ADDENDUM No. 2

Date: November 15, 2019

Re: UNC Charlotte – Residence Hall Phase XVI
SCO ID: 18-18333-02A
JPA Project #: 18NCC016

EVACUATION SIGNAGE

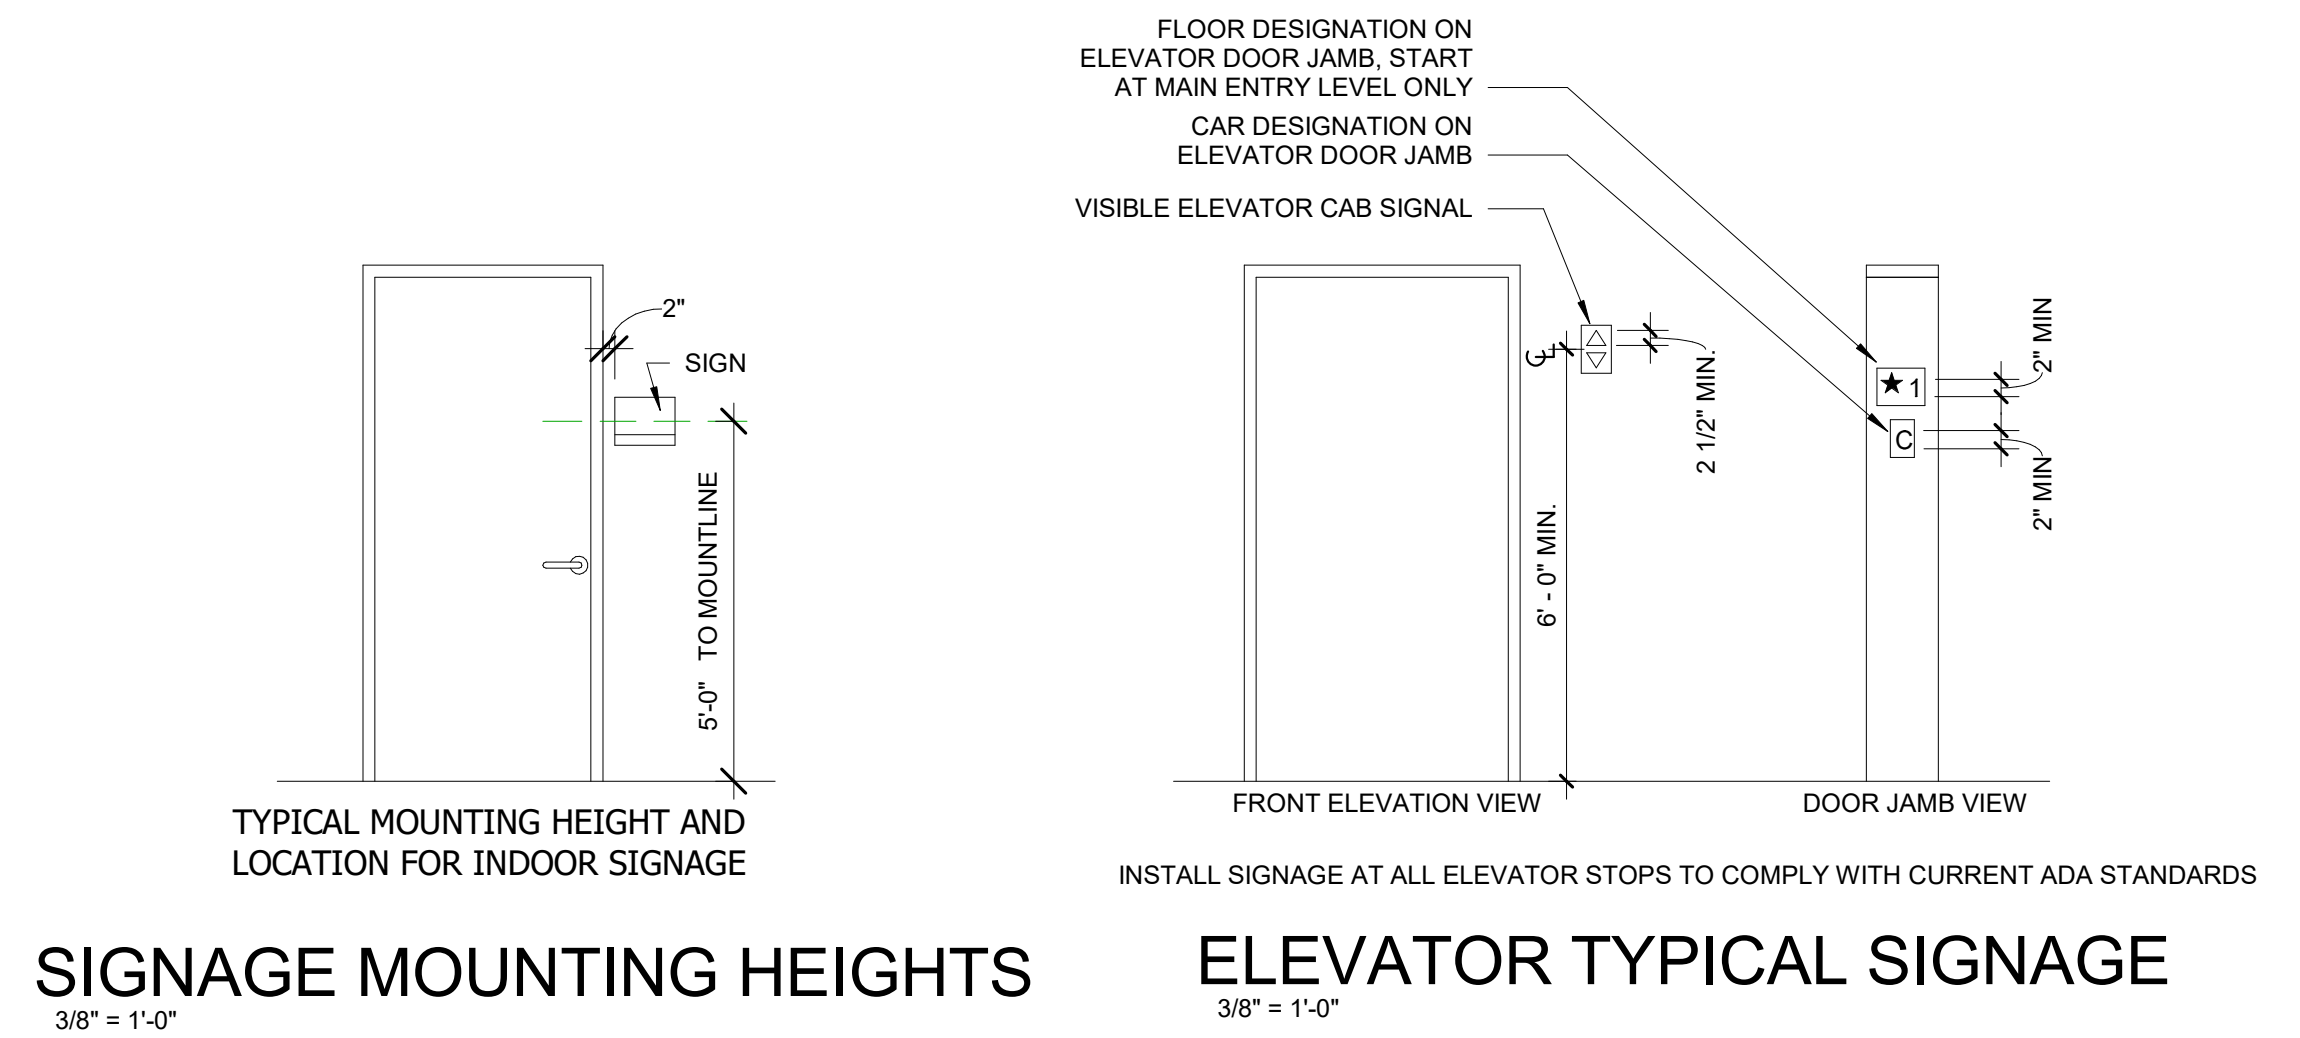
A-624 – Updated with clouded revisions for addition of Evacuation Signage
E-200-S – Lower Level Power Plan -South – Updated with clouded revisions for motorized shades
E-803 – Panel Schedules – Lower Level - South – Updated with clouded revisions for motorized shades

1 LOWER LEVEL POWER PLAN - SOUTH
 1/8" = 1'-0"

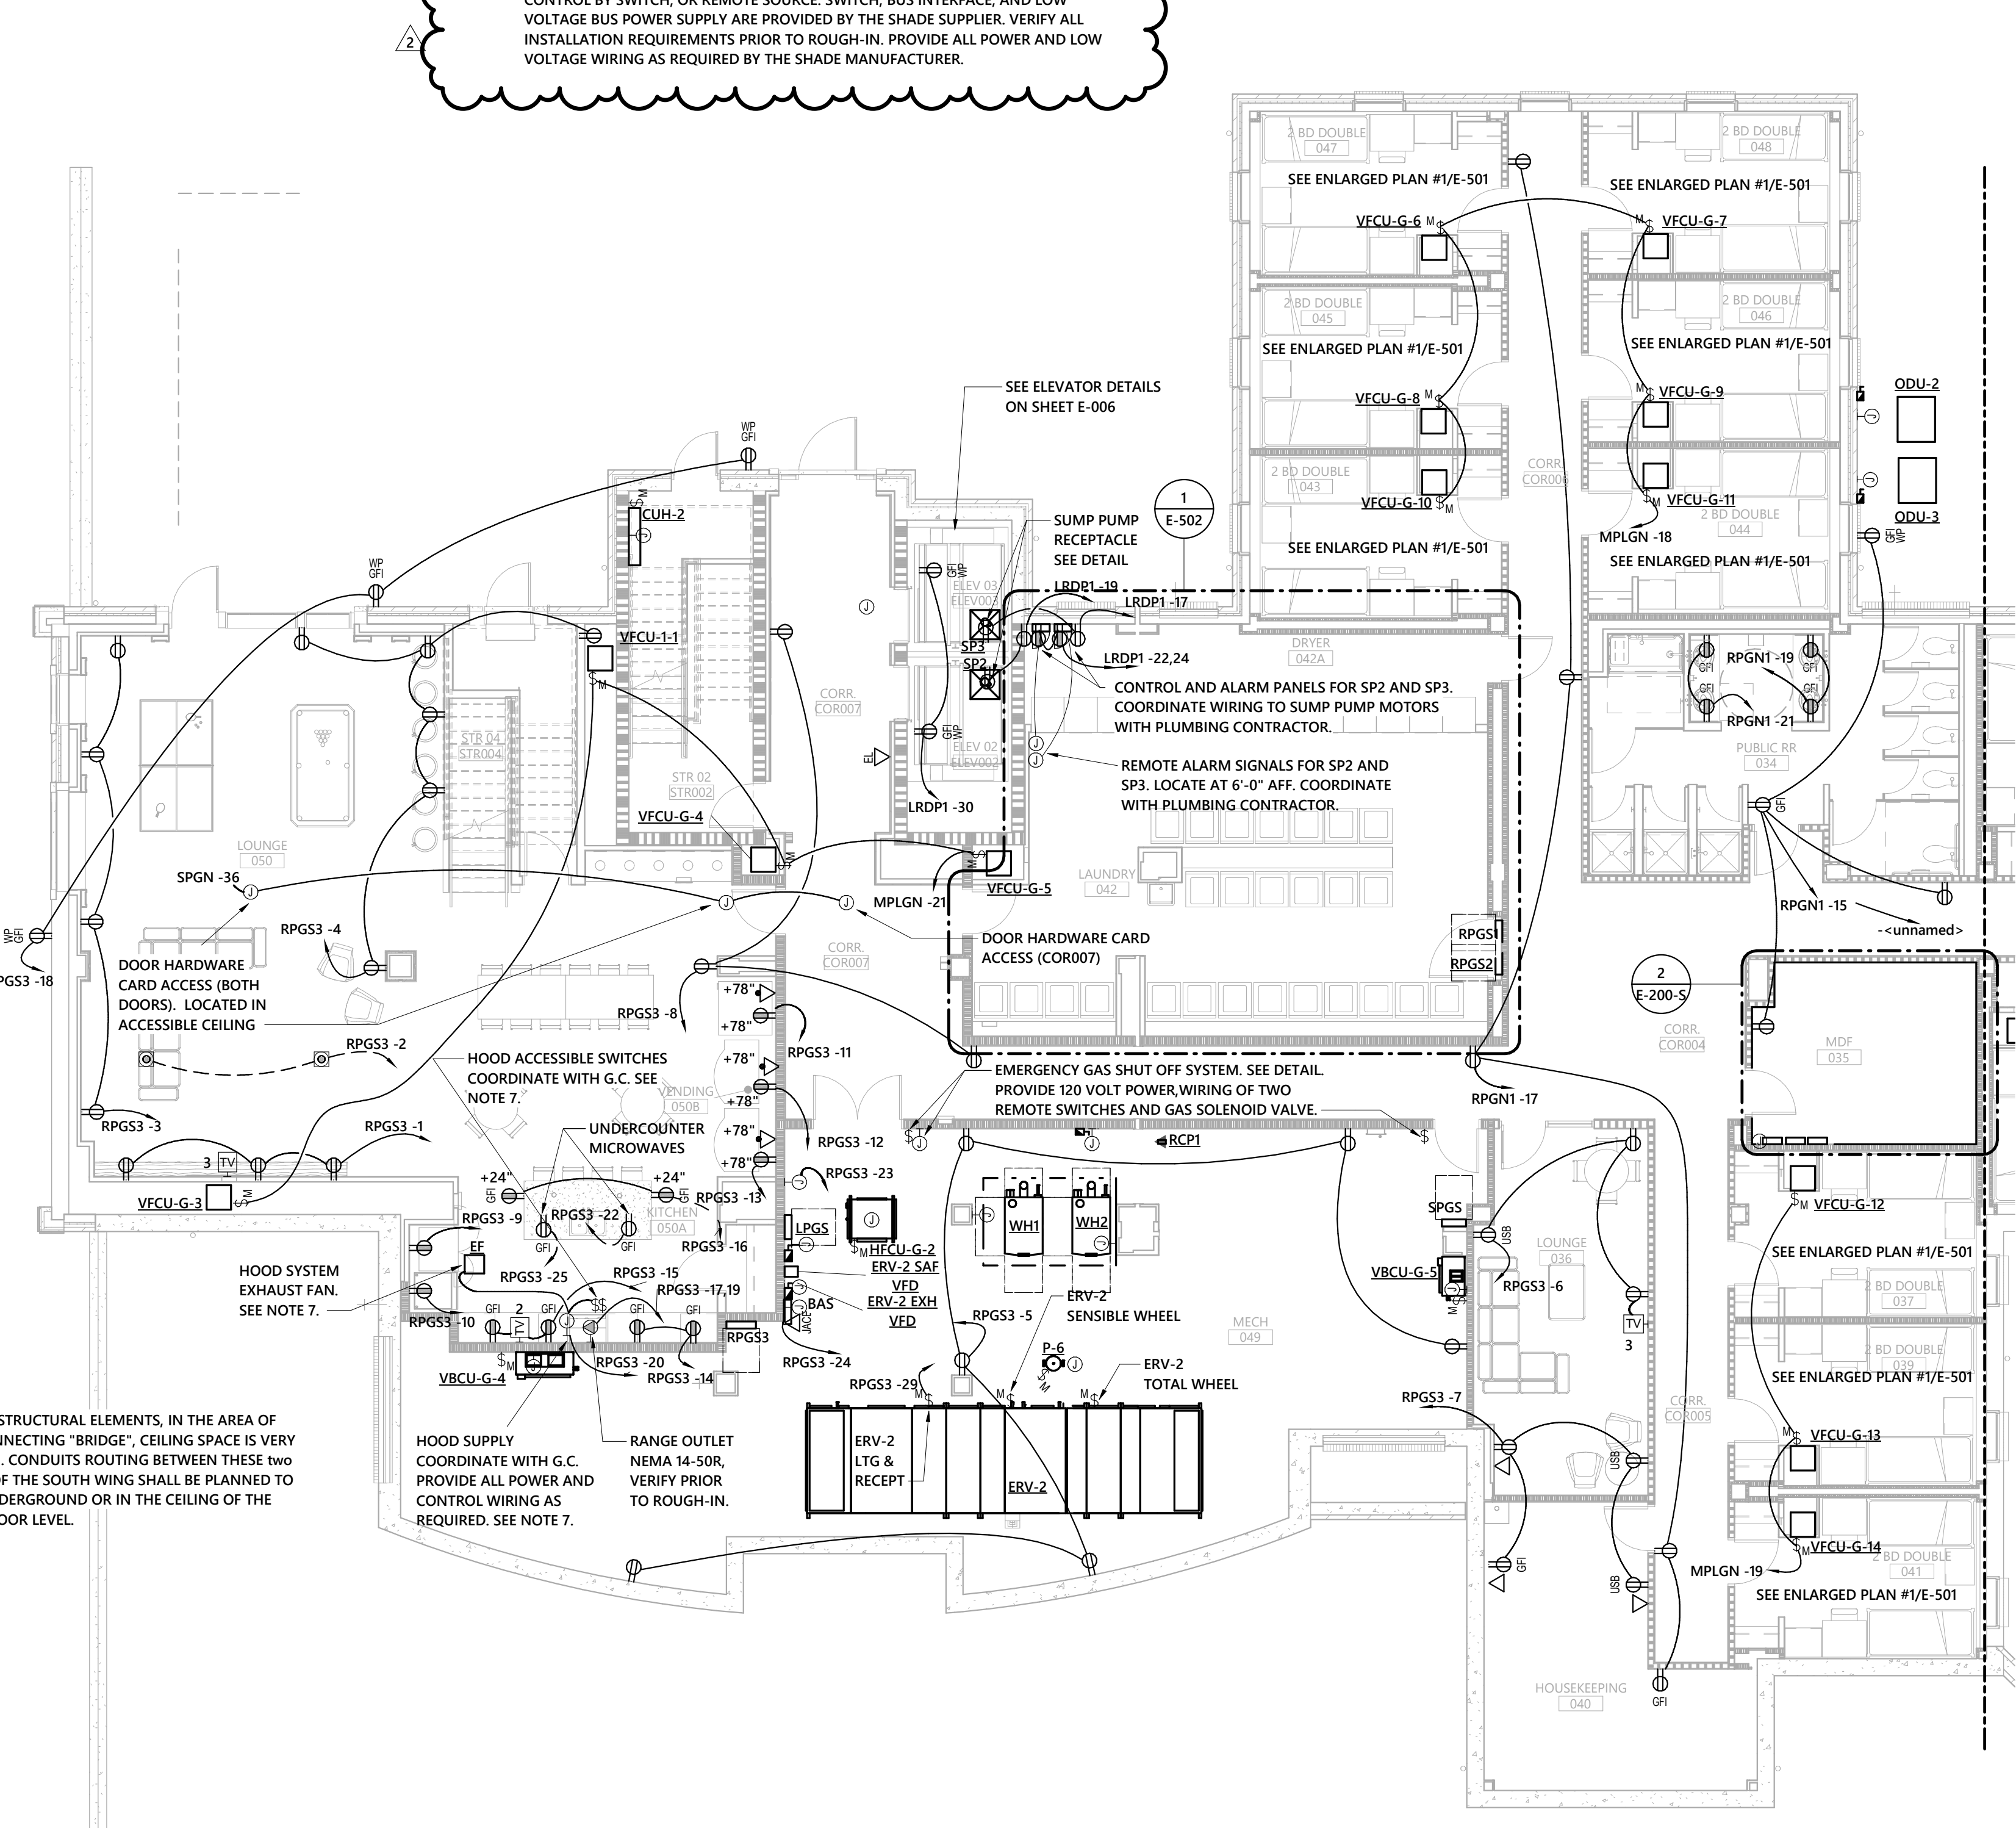
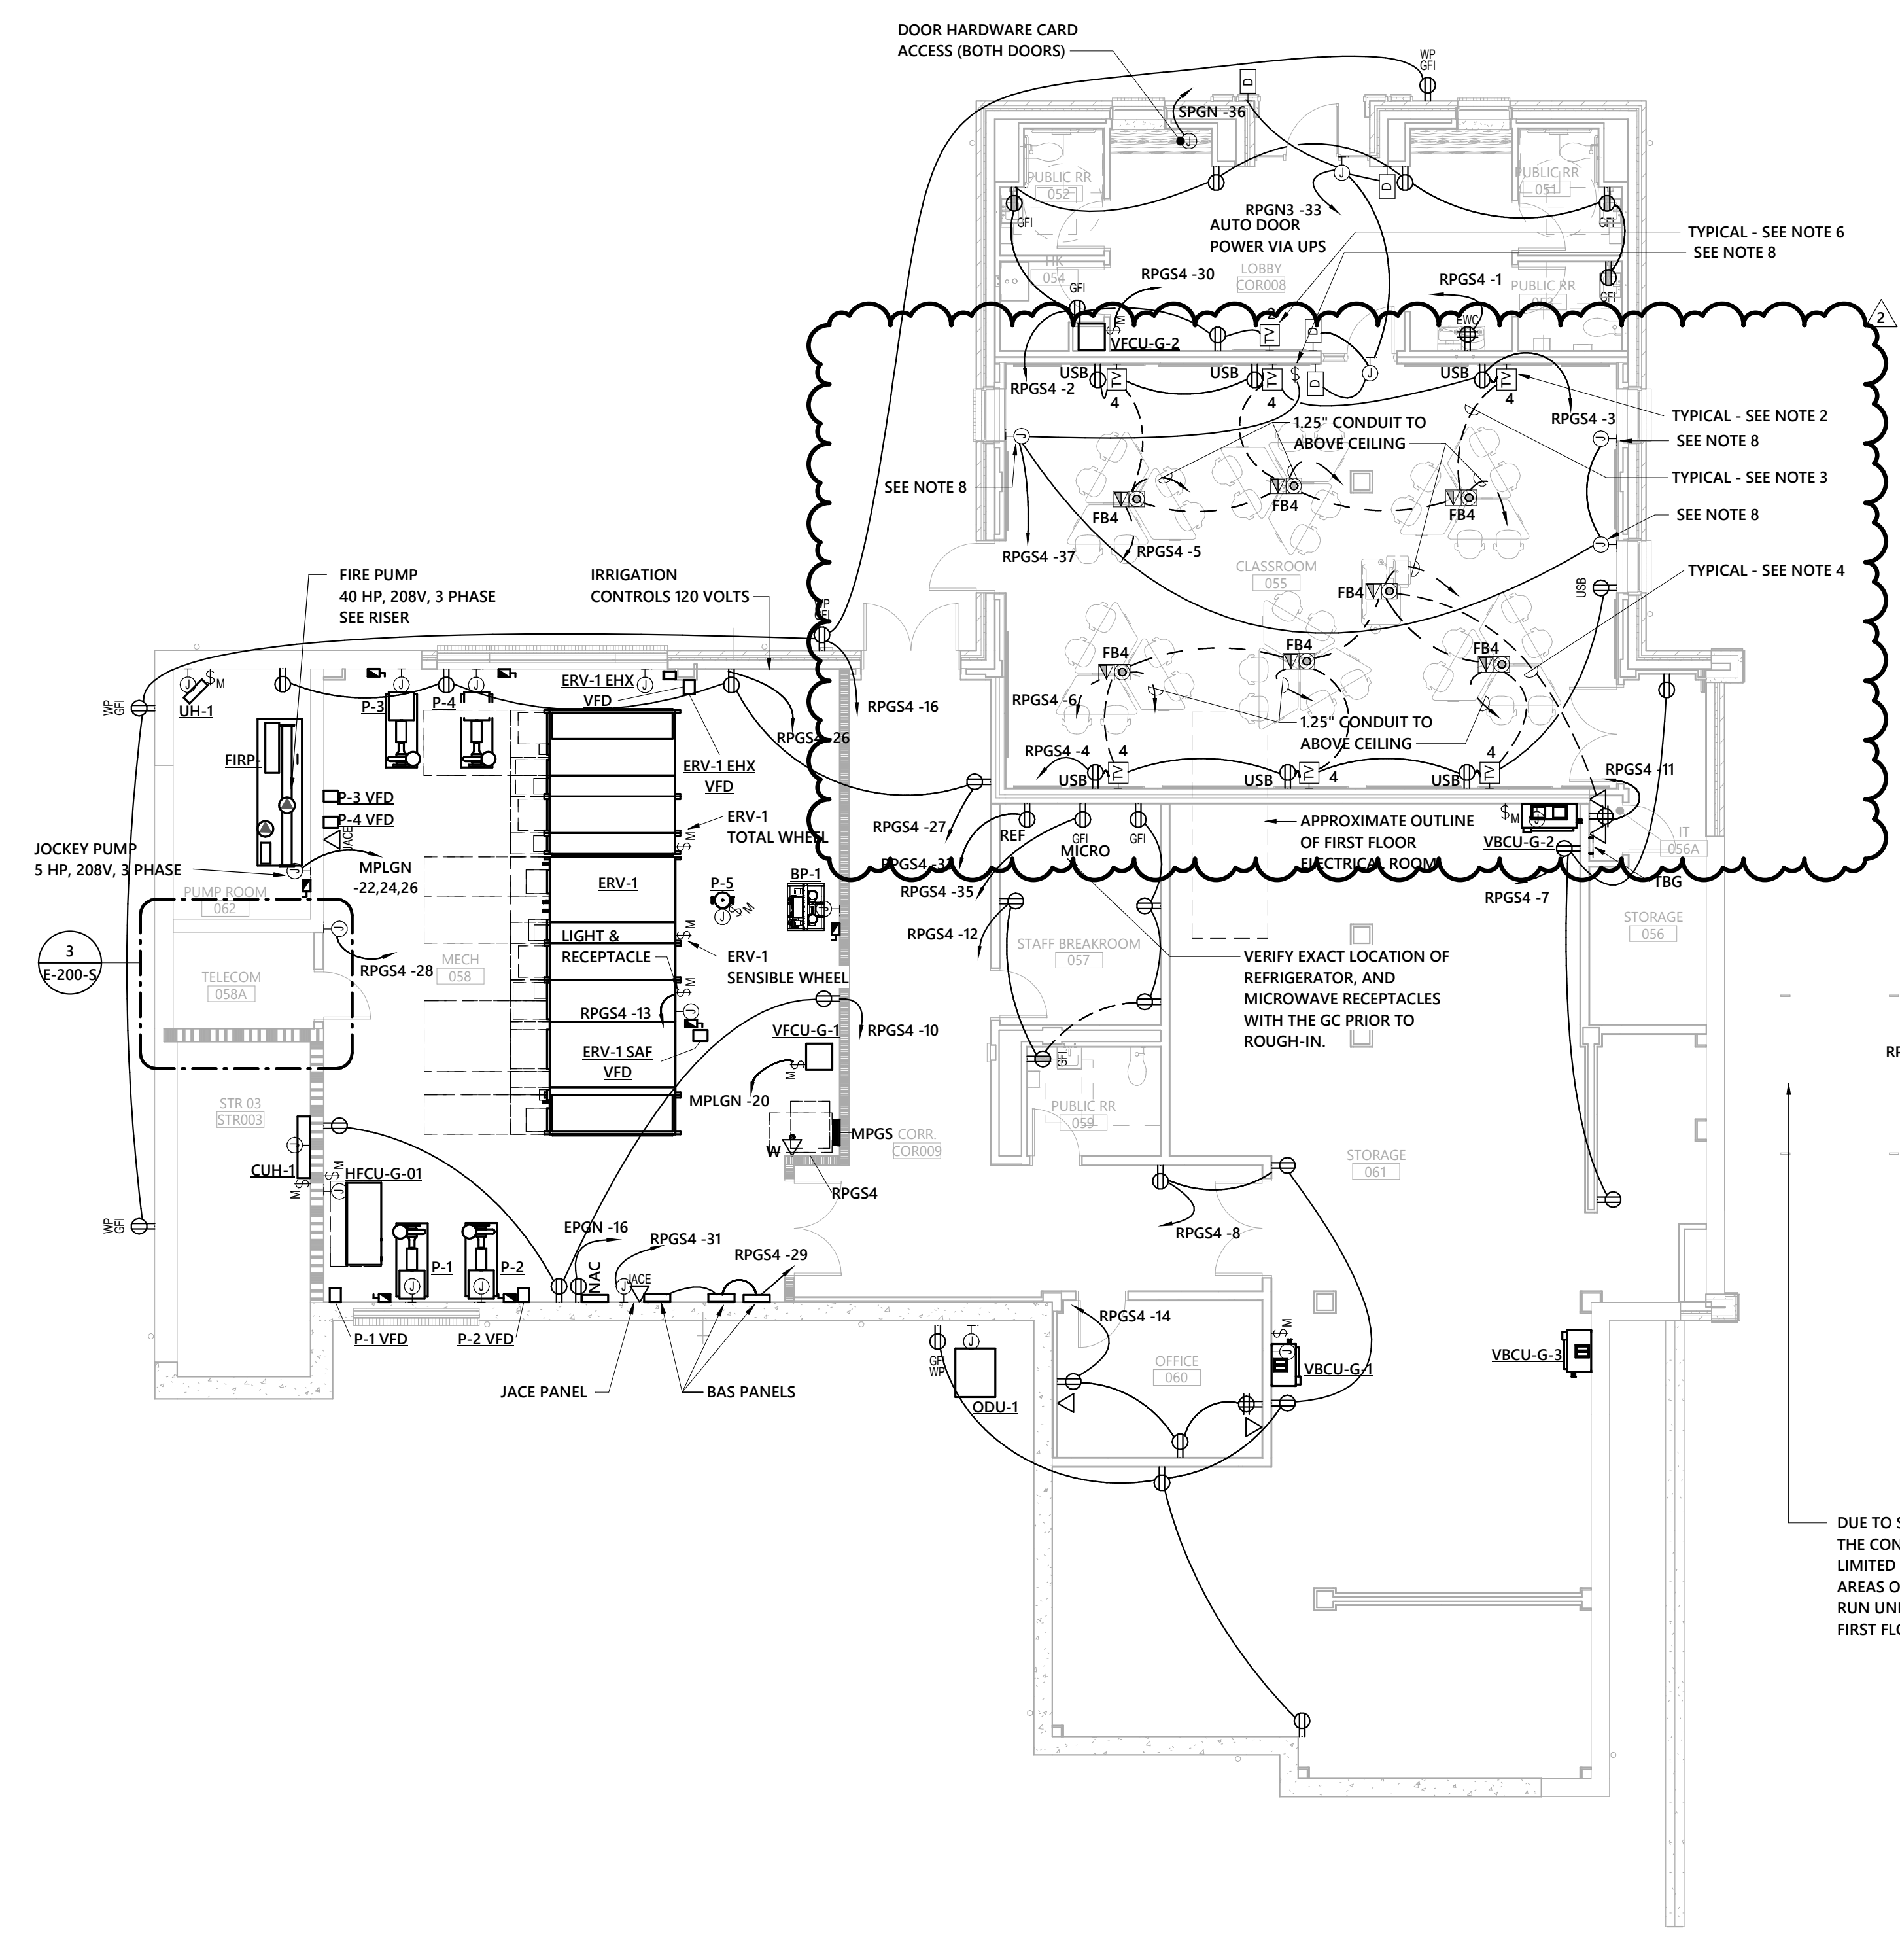
RESPONSE: Locations of shades are scheduled in section 12 24 13 2.6. Motorized shades are only required in Classroom 055. All other shades are manual. See revised electrical sheets included in this addendum for power requirements for motorized shades.

- ELECTRIC SHADES, 120 VOLTS, 2.3 AMPS PER MOTOR. COORDINATE ALL WIRING AND INSTALLATION OF WALL SWITCHES, BUS INTERFACE, BUS POWER SUPPLY AND CONNECTION TO MOTORS. EACH MOTOR HAS A SEPARATE ELECTRONIC ADDRESS FOR CONTROL BY SWITCH OR REMOTE SOURCE SWITCH, BUS INTERFACE, AND LOW VOLTAGE BUS POWER SUPPLY ARE PROVIDED BY THE SHADE SUPPLIER. VERIFY ALL INSTALLATION REQUIREMENTS PRIOR TO ROUGH-IN. PROVIDE ALL POWER AND LOW VOLTAGE WIRING AS REQUIRED BY THE SHADE MANUFACTURER.
